December 2015
FL679A-D
NHTSA #15V-127
Transport Canada #2015-113
REVISED NOTICE

Subject: Freightliner Cascadia SAM Chassis

Models Affected: Specific Freightliner Cascadia vehicles manufactured March 26, 2007, through September 1, 2010, and equipped with a SAM Chassis.

REVISION: Step 14 of the work instructions (page 10) has been updated to allow for a greater ohm value for the first of the three pin connections. Pin X58-18 to X58-3 should measure between 50 k to **300 k**.

Fig. 9, X58 Terminal Locations for Ohm Tests

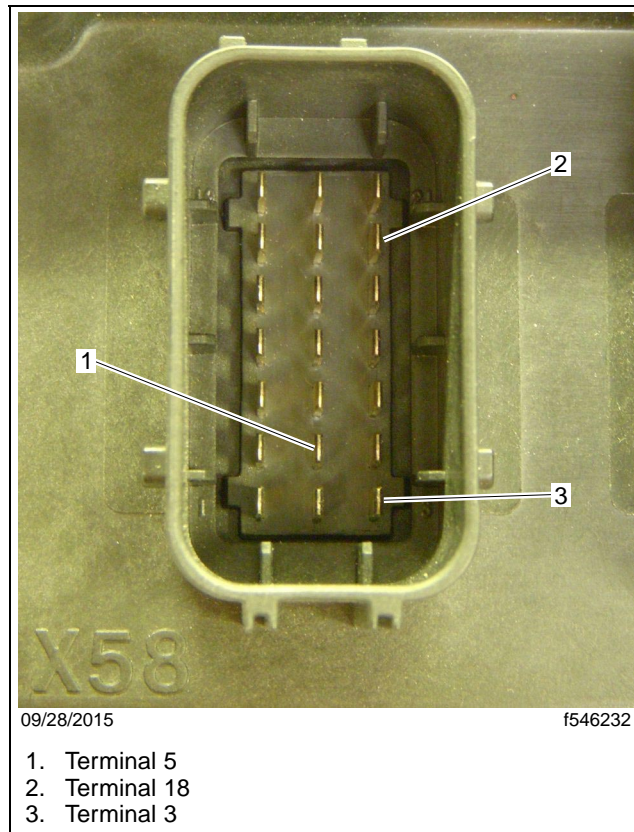
REVISION: Step 14 of the work instructions (page 10) has been updated to allow for a greater ohm value for the first of the three pin connections. Pin X58-18 to X58-3 should measure between 50 k to **300 k**.

14. Perform an ohm test on the SAM Chassis. See **Fig. 9**.

- **X58-18 to X58-3**; should measure between 50 k Ω to 300 k Ω .
- **X58-18 to X58-5**; should measure between 50 k Ω to 150 k Ω .
- **X58-3 to X58-5**; should measure between 50 k Ω to 150 k Ω .
